Subject: License Amendment Application to Increase Spent Fuel Storage Capability
(License Amendment Request No. 98-0013)

APPLICATION FOR AMENDMENT
TO
FACILITY OPERATING LICENSE NUMBER NPF-3
DAVIS-BESSE NUCLEAR POWER STATION
UNIT NUMBER 1

**SAFETY ASSESSMENT AND SIGNIFICANT HAZARDS CONSIDERATION
FOR
LICENSE AMENDMENT REQUEST NUMBER 98-0013**

Proposed Modifications to the Davis-Besse Nuclear Power Station (DBNPS) Unit Number 1, Facility Operating License NPF-3, Appendix A Technical Specifications, to Allow an Increase in the Spent Fuel Storage Capability.

Figure 3.9-1
Burnup vs. Enrichment Curves
For the Davis-Besse Low Density
Spent Fuel Pool Storage Racks

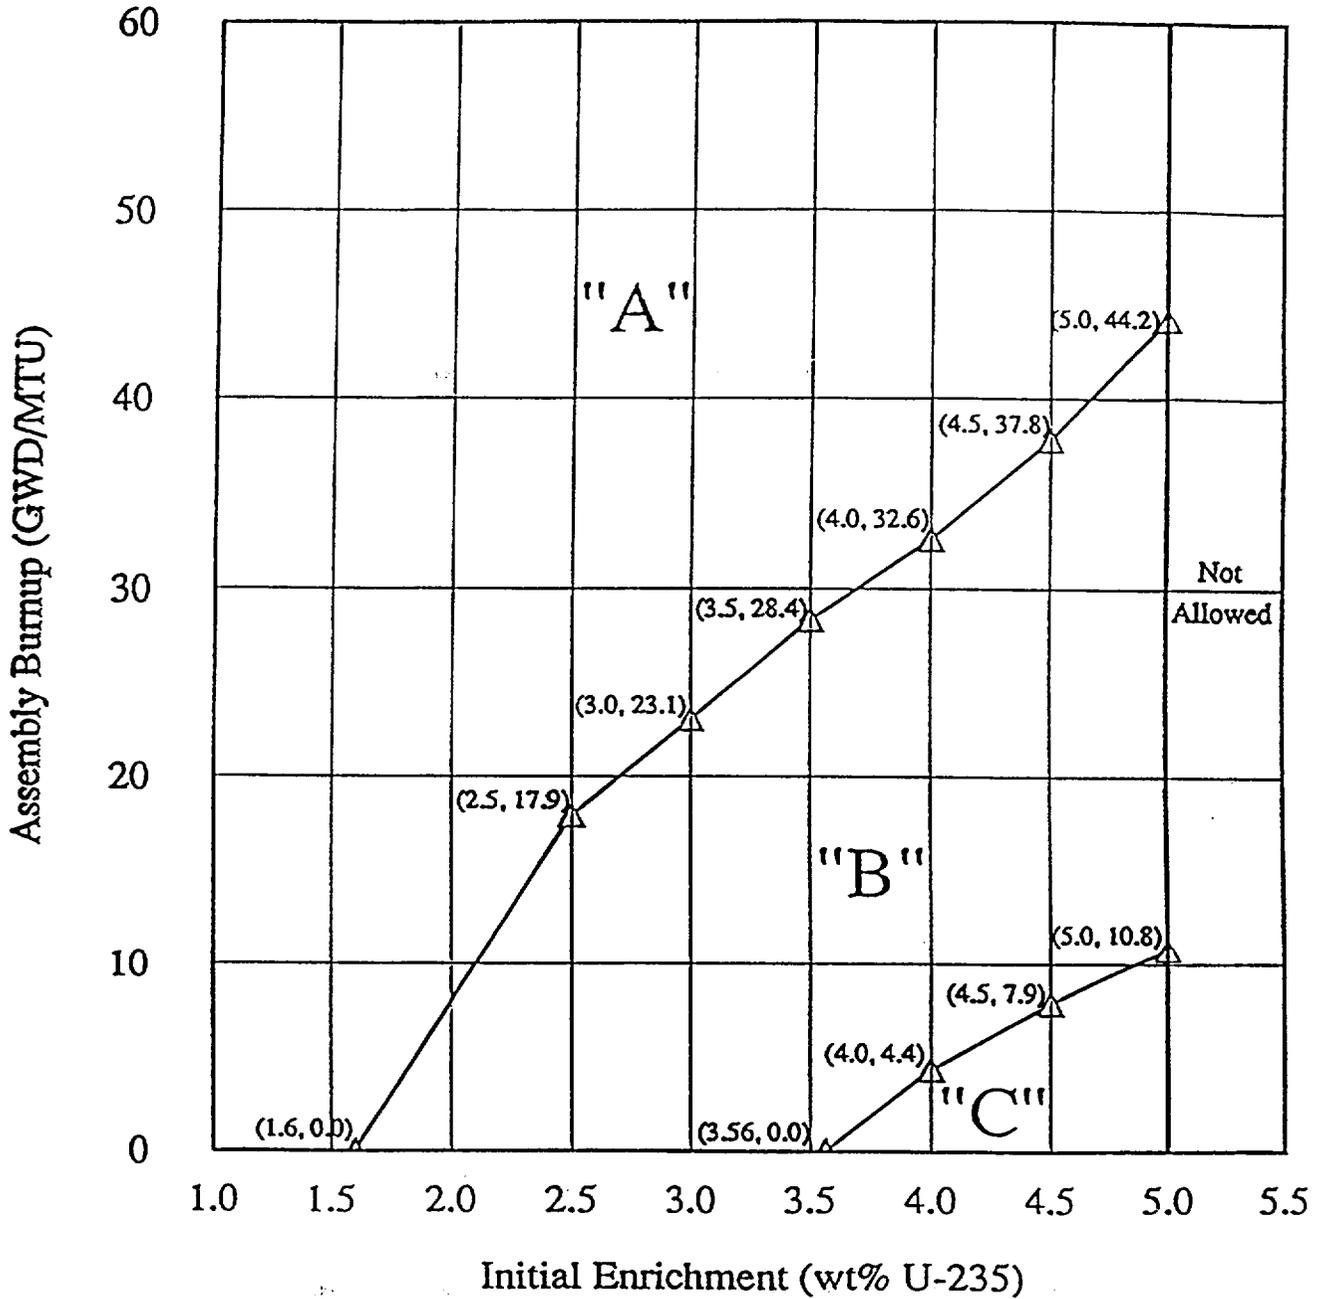
It is proposed to revise LCO 3.9.13 and SR 4.9.13.1 to include provisions regarding storage of fuel assemblies in high density racks in the SFP and the transfer pit. In addition, the title of Figure 3.9-1 is proposed to be revised to clarify that it applies to the low density racks in

Bases changes are proposed that relate to the proposed changes to the associated LCO. An additional Bases change is proposed that clarifies that the term “directly adjacent” as used in Figure 3.9-1 refers to fuel assemblies stored face-to-face. These Bases changes are administrative changes that will have no adverse effect on nuclear safety.

Figure 3.9-2
Burnup vs. Enrichment Curve
For the Davis-Besse High Density
Cask Pit Storage Racks

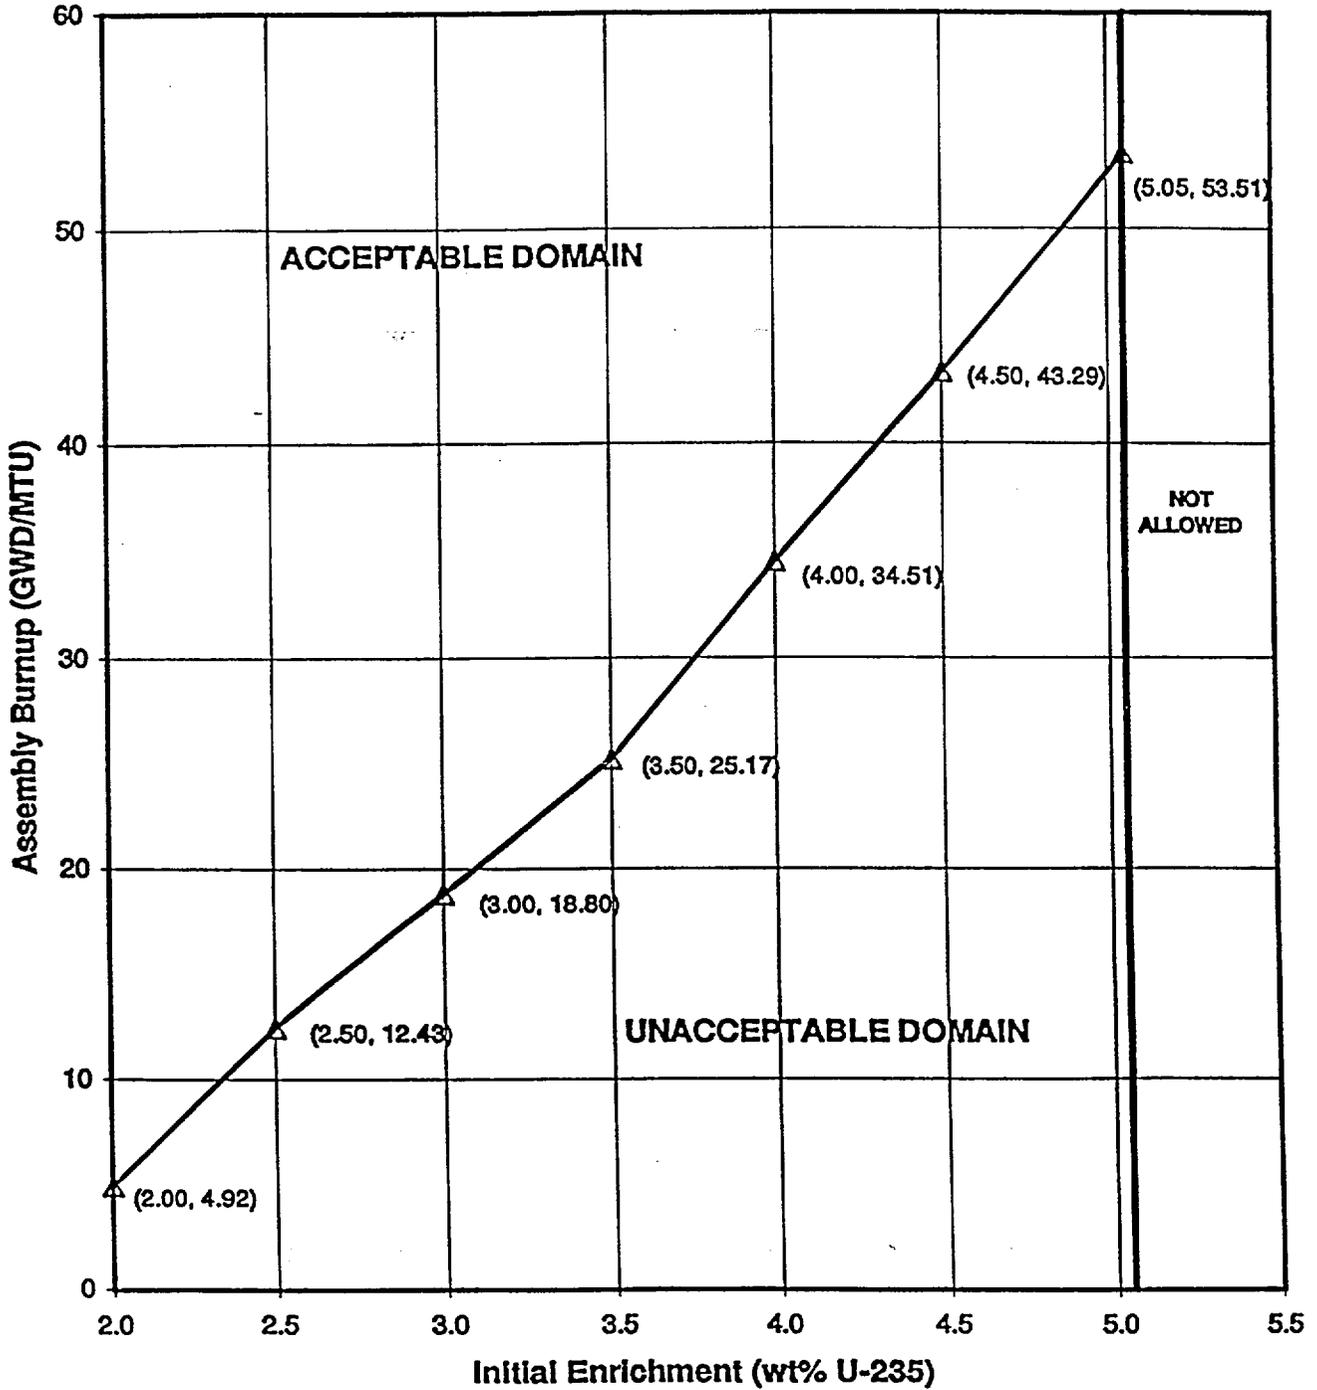
the SFP, and the title of Figure 3.9-2 is proposed to be revised to clarify that it applies to the high density racks in the cask pit. A new Figure 3.9-3 is proposed to be added that applies to the high density racks in the SFP and transfer pit. Related changes to Bases 3/4.9.13 are also proposed, including the addition of cross-references to Specifications 5.6.1.1 and 5.6.1.3 for a description of the design features of the low and high density spent fuel storage racks, respectively. In addition, a change to Bases 3/4.9.13 is proposed to clarify the term “directly adjacent” as used in Figure 3.9-1.

Figure 3.9-3
Burnup vs. Enrichment Curves
For the Davis-Besse High Density
Spent Fuel Pool and Transfer Pit Storage Racks

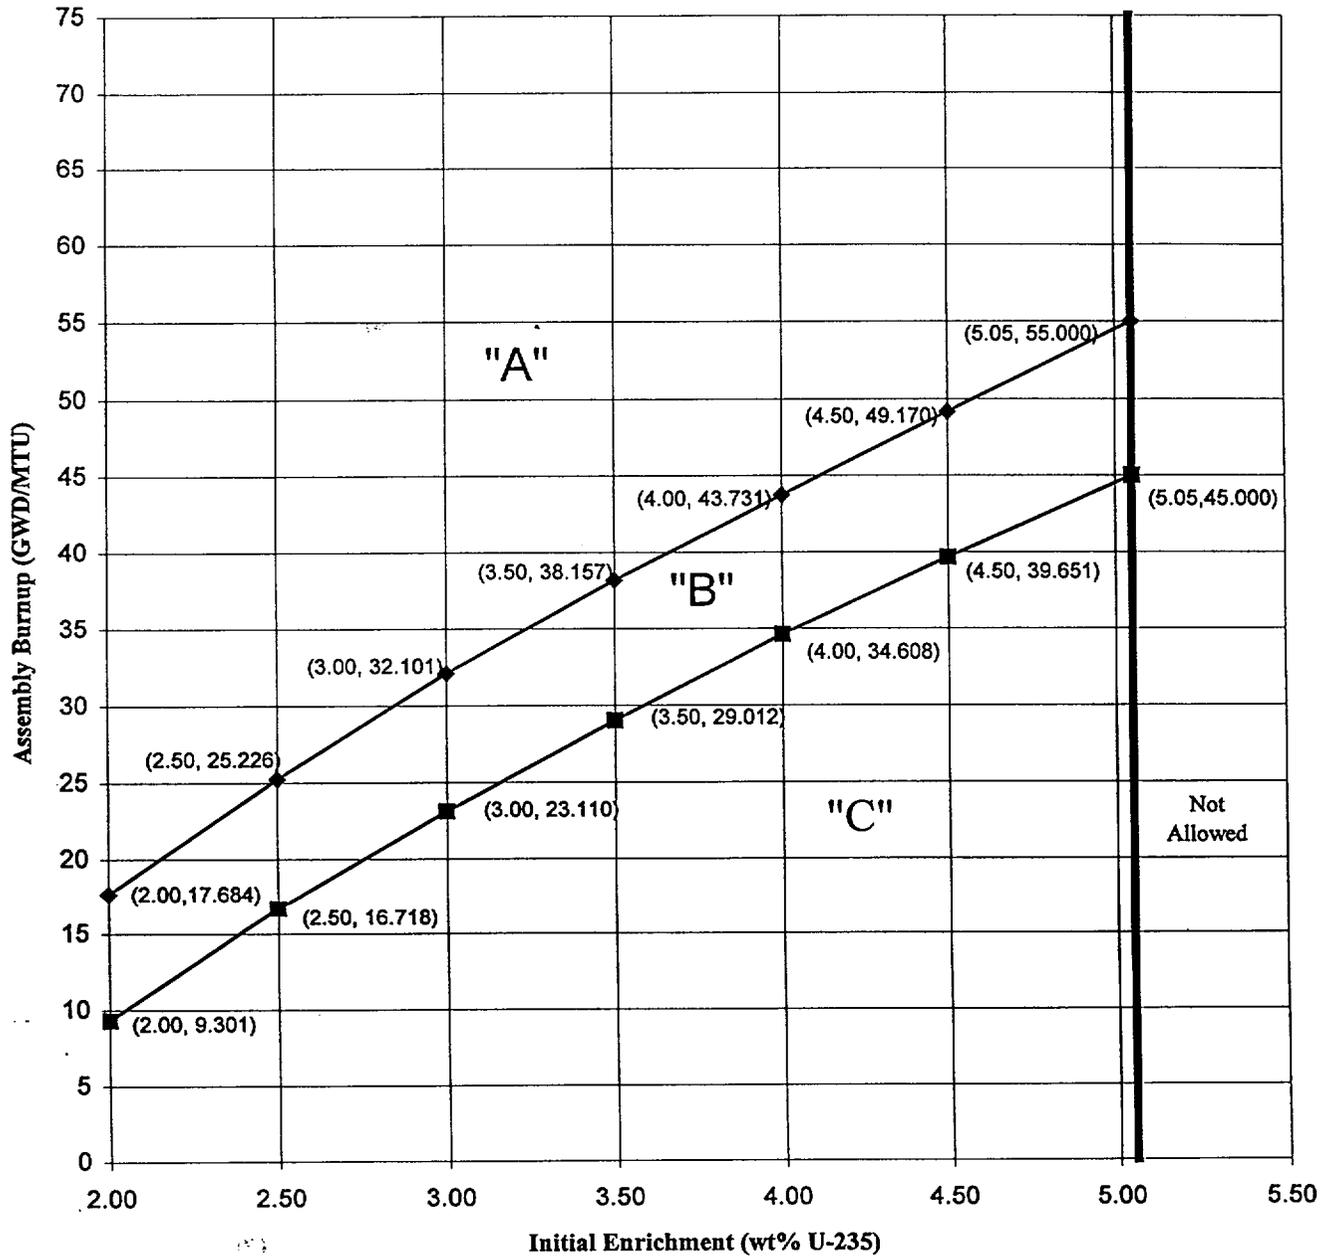
The proposed new Figure 3.9-3, "Burnup vs. Enrichment Curves For the Davis-Besse High Density Spent Fuel Pool and Transfer Pit Storage Racks," incorporates new requirements specific to the new spent fuel storage racks. The figure provides burnup/enrichment limitations appropriate for the spent fuel storage rack configurations, consistent with the criticality safety analyses performed. As such, this proposed change will have no adverse effect on nuclear safety.
